**COALFIELD DEVELOPMENT CORPORATION
CABELL COUNTY, WEST VIRGINIA
JUST TRANSITION CENTER
ADDENDUM #6
March 5, 2026
THRASHER PROJECT # T60-11108**

A Pre-Bid Conference was held on Tuesday, February 3, 2026, on the above-referenced project. The following are clarifications and responses to questions posed by contractors for the above-referenced project.

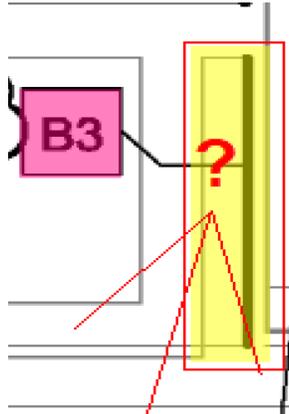
Refer to screenshot below of area between Storage 101 & Storage 104.

Could you elaborate on the intent of furring out a wall in an enclosed area?

Intent is to provide 1 hour fire separate from Storage 101 and Storage 104.

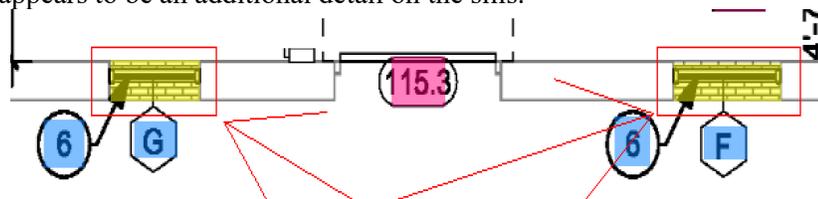
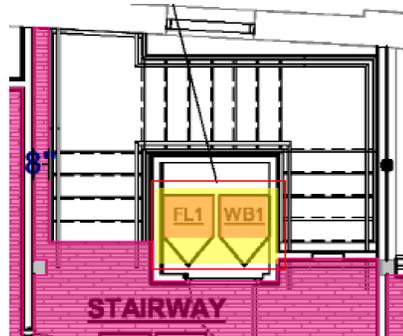
Refer to screenshot below. These two areas are the only two areas at the windows where there appears to be an additional detail on the sills.

Can you elaborate on the intent of the additional sill detail?

No special or supplemental sill condition are intended at these two window locations. The apparent additional detail is a drafting software graphic error and shall be disregarded.

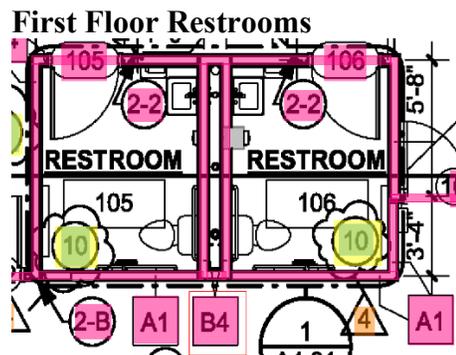
B. Clean-Agent Type in Steel Container: UL-rated 1-A:10-B:C, 10-lb nominal capacity, with HFC

blend agent and inert material in enameled-steel container; with pressure-indicating gage. Requesting standard FE10C 10lb Fire Extinguisher by Cosmic to be an approved equal. The mercury fire extinguishers are 3-times the cost of a Standard Fire Extunisher.

Approved. Multipurpose Dry-Chemical Type: UL-rated 10 lb nominal capacity, with monoammonium phosphate-based dry chemical in manufacturer's standard enameled container.

Wall Type B4

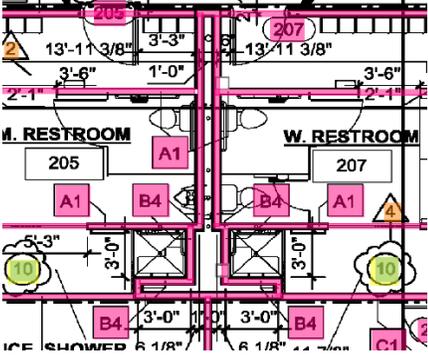
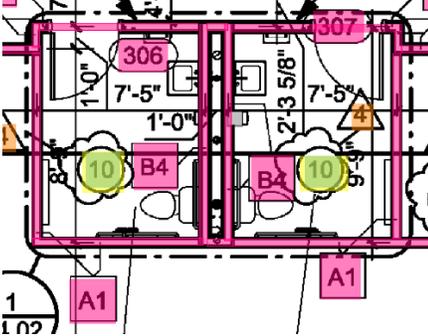
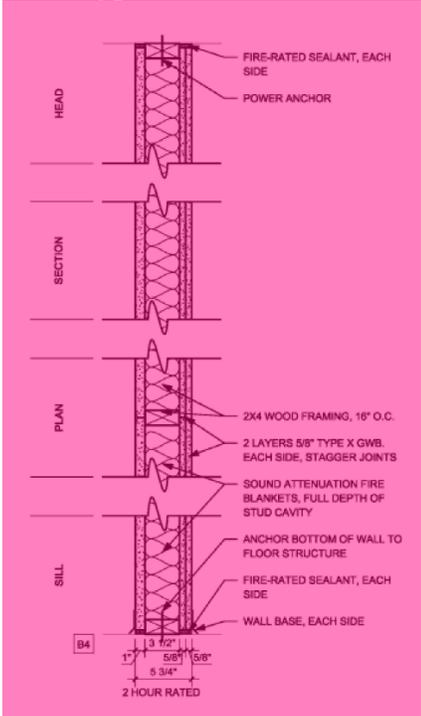
Requesting confirmation, the wet walls located in the restrooms are intended to be tagged B4.

Correct, provide mold-resistant gypsum board.

Wall Type B4

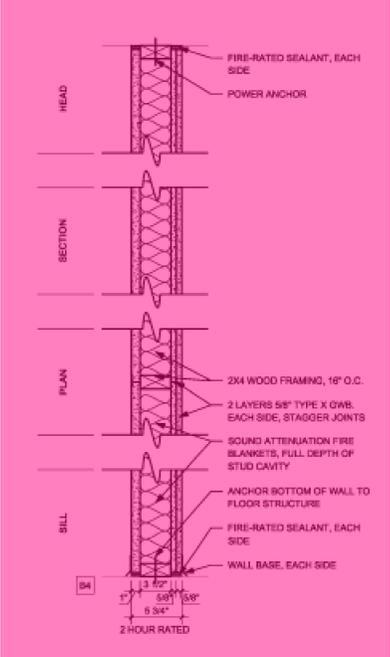
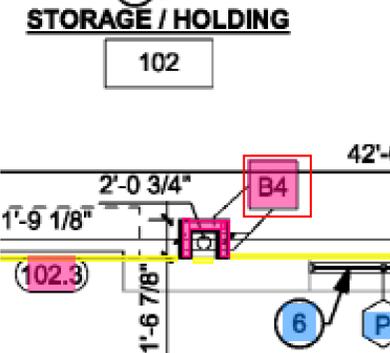
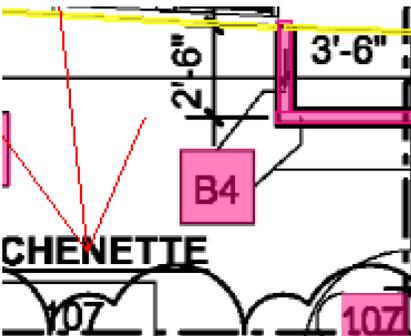
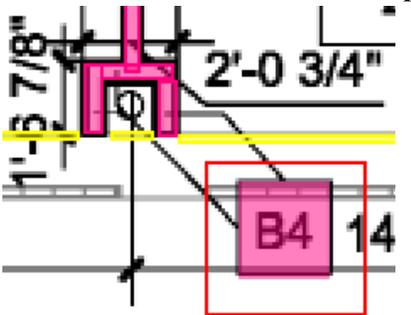
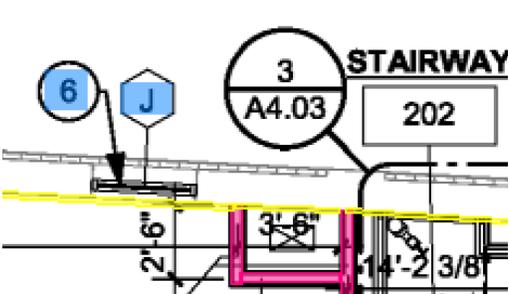
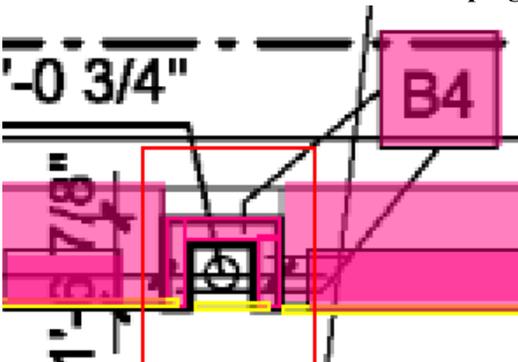
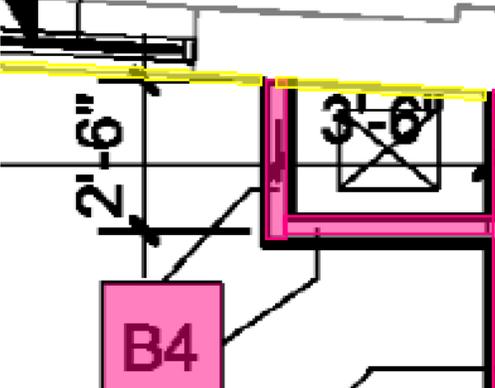
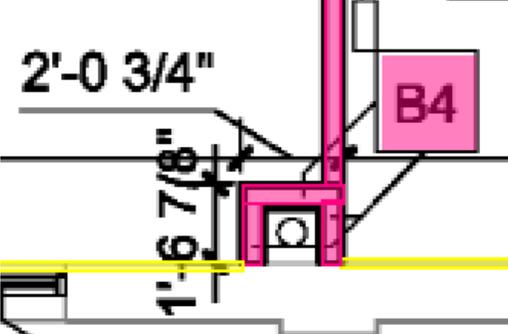
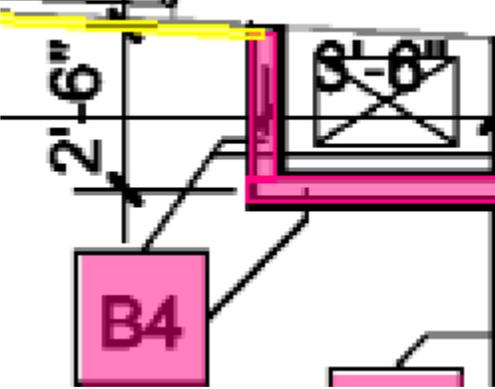
Review screenshots below.
Requesting confirmation of the Tagged Wall Type 4 for the Storm Piping Chase. Should the 2-hour rating be required at the storm piping chases, requesting approval or 2-hour shaft wall assembly as an Alternate for Wall Type B detail.
Requesting approval for 2-hour shaft wall assembly as an Alternative for the Wall Type B4 detail at Mechanical chases.

1. Will existing MEP's be demoed from the ceilings to allow for the leveling of the floors?
2. Should Demolition Note 17 be included in Base Bid in lieu of Alternate No. 02?

RESPONSE

1. Yes, include MEP demo in the base bid.
2. Yes, revise Demolition Note 17 to be included in Base Bid.

3. QUESTION

AD1.04 Third Floor Plan-Demolition, Demolition Note 17 is not tagged on the floor plan.

2-hour shaft wall assembly as an acceptable alternate for wall types B and B4.

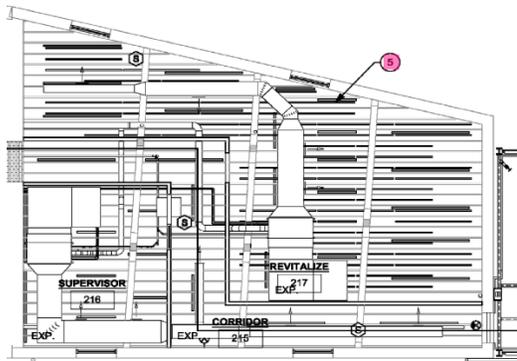
There seems to be a discrepancy with the phasing for the fire pump in relationship with the generator.

Requesting confirmation on the electrical requirements for the fire pump.

If the current flow test shows there is enough pressure to operate the system in accordance with NFPA and meet all local AHJ requirements then a fire pump is not required. All plumbing components and electrical components associated with the generator and fire pump can be removed from the plans. Verify with sprinkler contractor and electrical contractor.

1 FIRST FLOOR PLAN - DEMOLITION
AD1.01 1/8" = 1'-0"
0' 5' 10' 20'

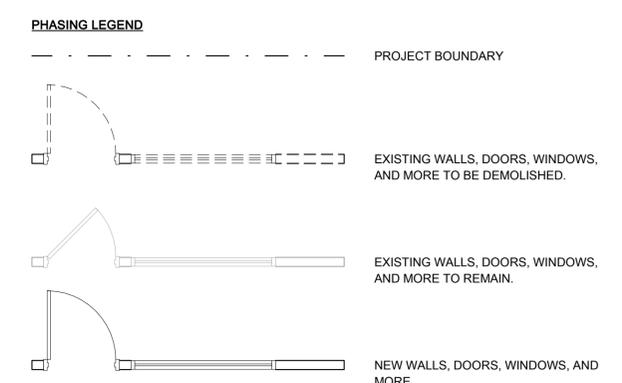
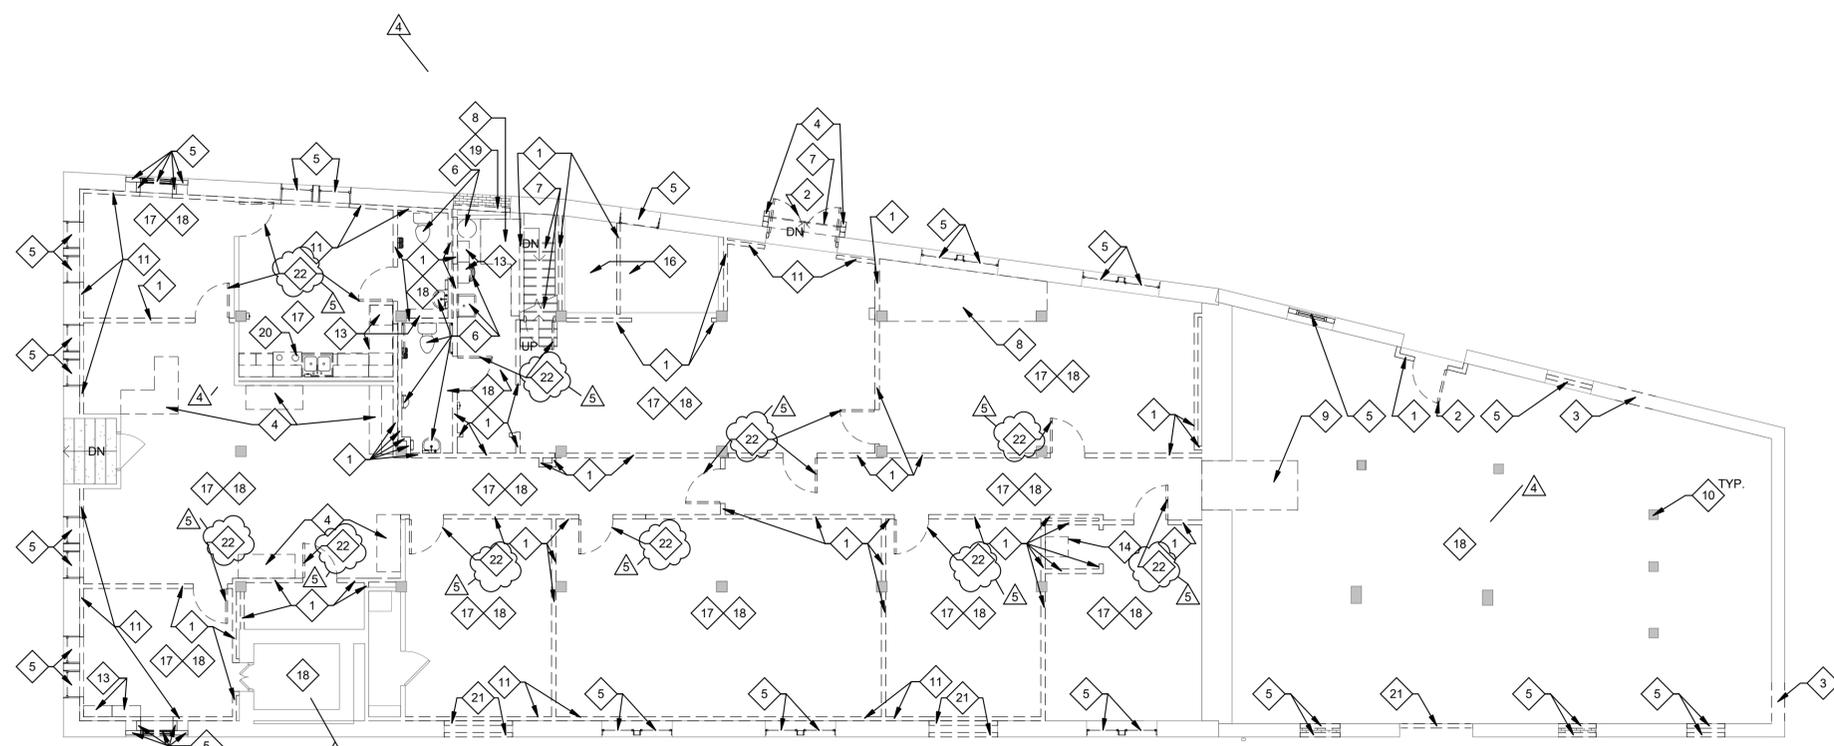
Sheet AD1.00, AD1.01, AD1.02, AD1.03, & AD1.04 Note 2. Confirm remove existing door and frame is to be included in Alternate No. 01 and not Alternate No. 02.

Clarification provided in this addendum.

1 FIRST FLOOR PLAN - PROPOSED
 A1.01 1/8" = 1'-0"

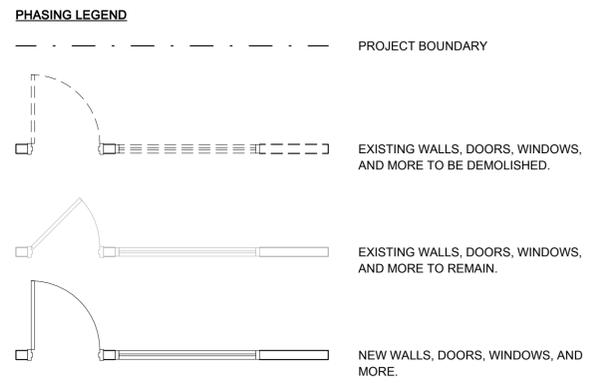
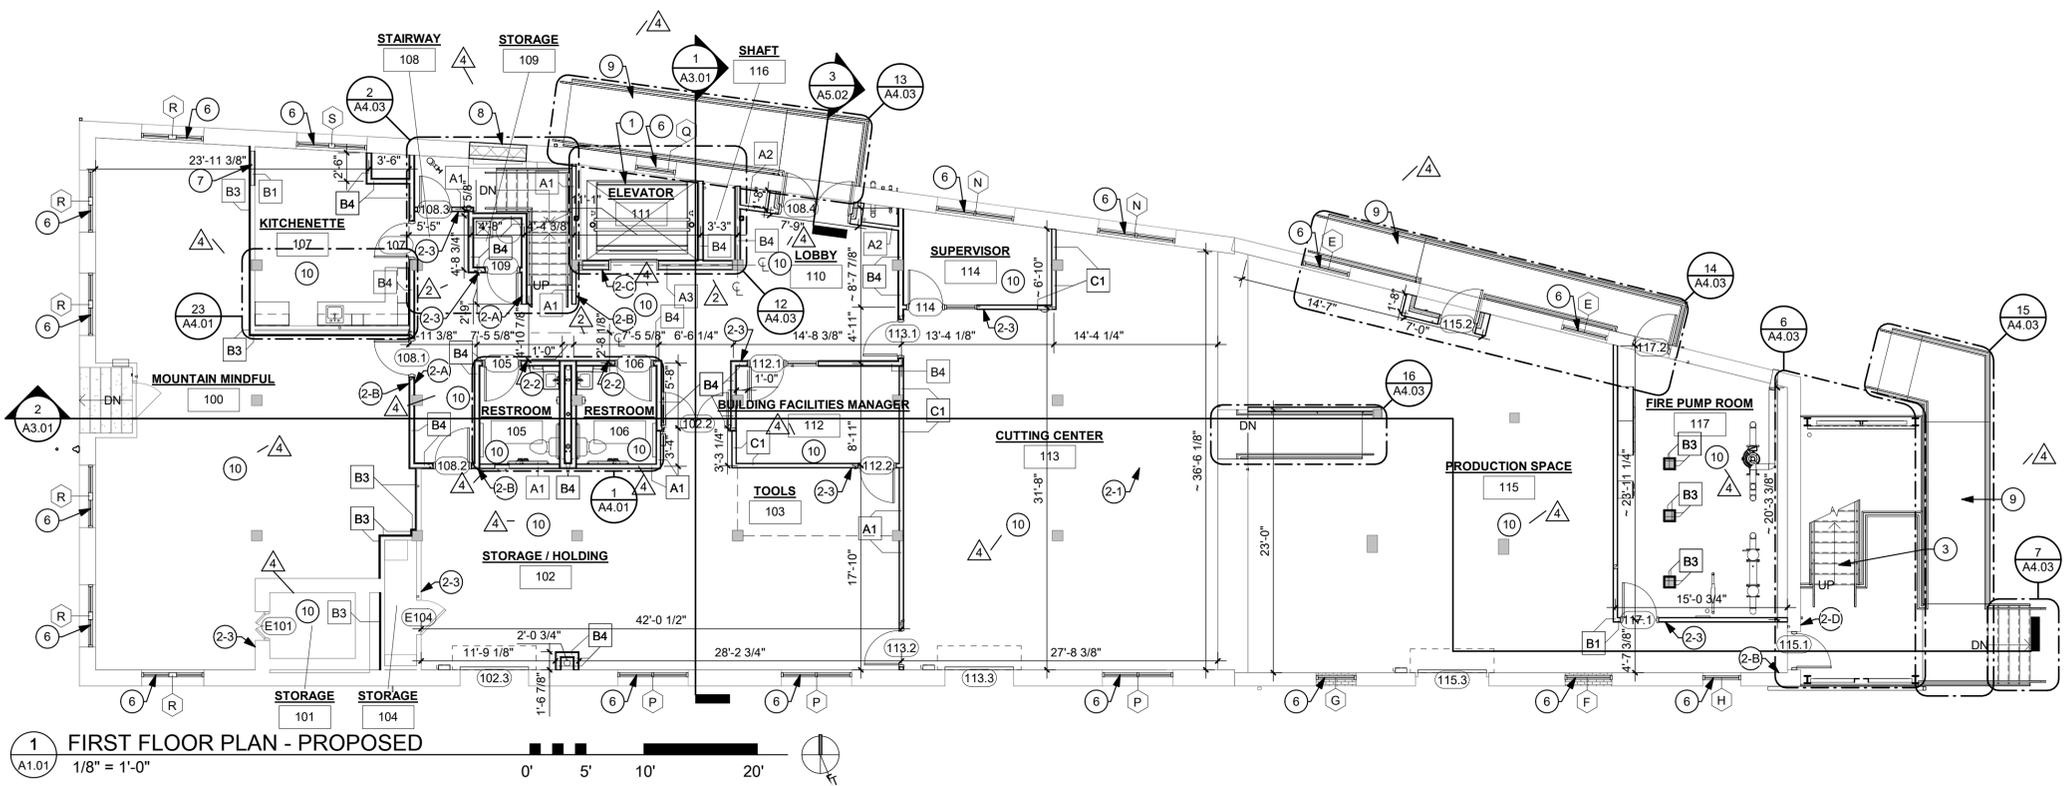
Sheets A1.01, A1.02, A1.03, & A1.05; New Construction Plan Note 10: Alternate No. 01 Install new hardwood on new three-quarter tongue and groove plywood subfloor. Sheets A7.01 Finish Schedule and Sheets A7.02, A7.03, A7.04, & A7.05 title block identifies the hardwood floor and resilient base to be included in Alternate No. 02.

Which Alternate is correct?

Should the replacement of the 4x4's and three-quarter floor be included in Base Bid and the hardwood and base be included in Alternate No. 02?

Note 10 revised in this addendum.

3 ACOUSTICAL BAFFLES LAYOUT
A1.08 1/8" = 1'-0"

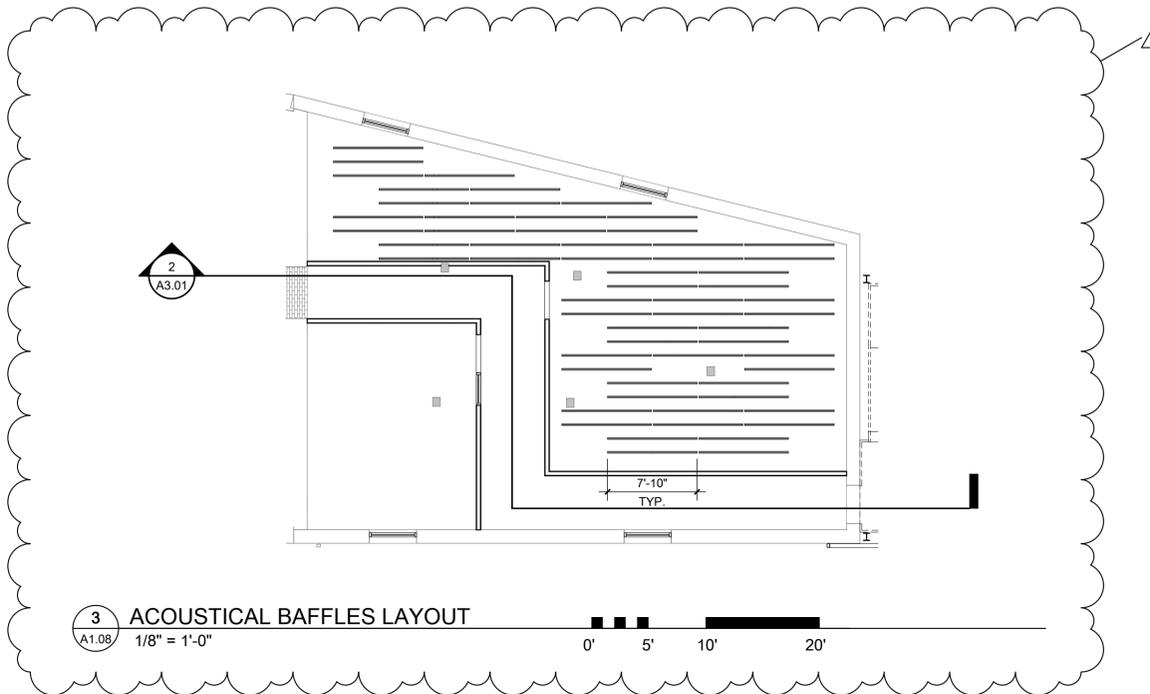
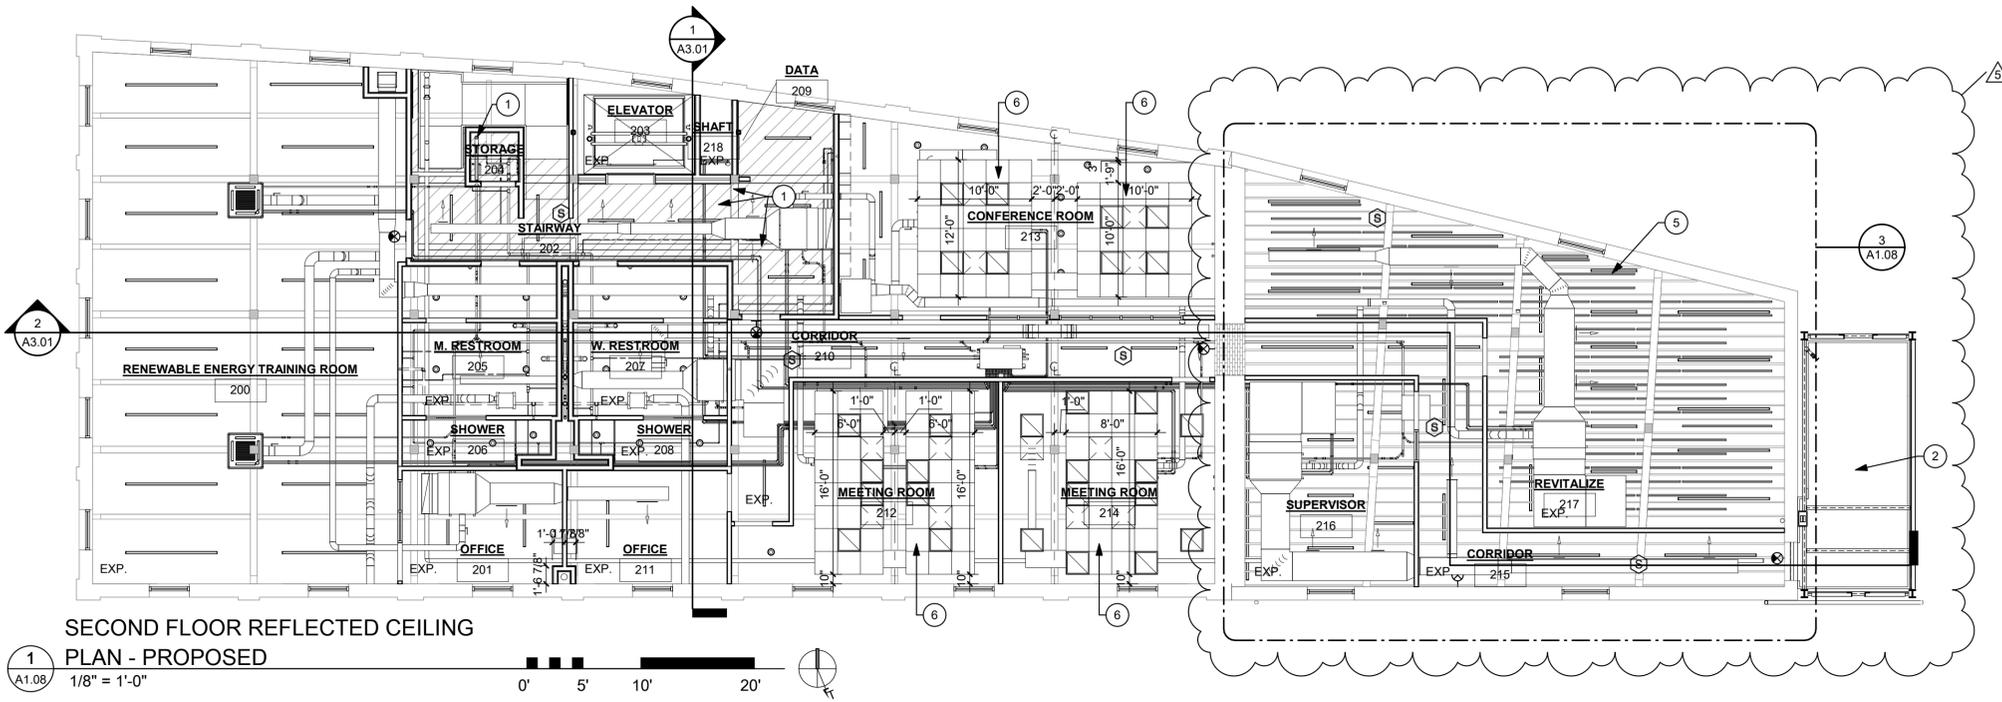
Referring to Sheet A1.08 New RCP Note 05 Acoustical Baffles. Refer to screenshot below. The Plan Sheet appears to identify two different widths of acoustical baffles with somewhat of a staggering design.

Could a revised Plan Sheet without the overhead MEP's be provided to show some clarity on the locations and sizing of the baffles?

Clarity drawing provided in this addendum.
